### REMARKS

VERSION WITH MARKINGS TO SHOW CHANGES MADE

*Fig. 4*

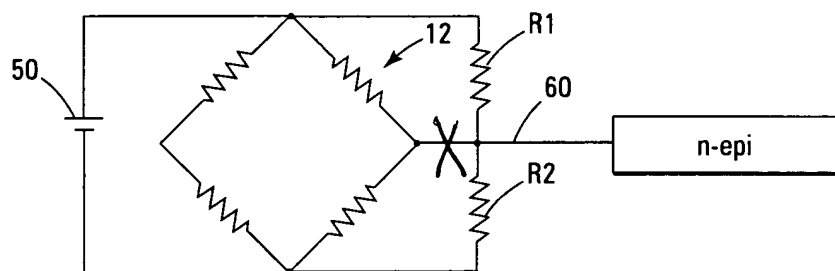
Upon review of the formal drawings filed March 1, 2002, a discrepancy between the drawing as filed and the formal drawing has been observed. The correction is marked in red on the enclosed FIG. 4, and a corrected substitute drawing is enclosed herewith, thereby bringing the recently submitted FIG. 4 into conformance with FIG. 4 as originally filed. Please acknowledge acceptance of corrected FIG. 4.
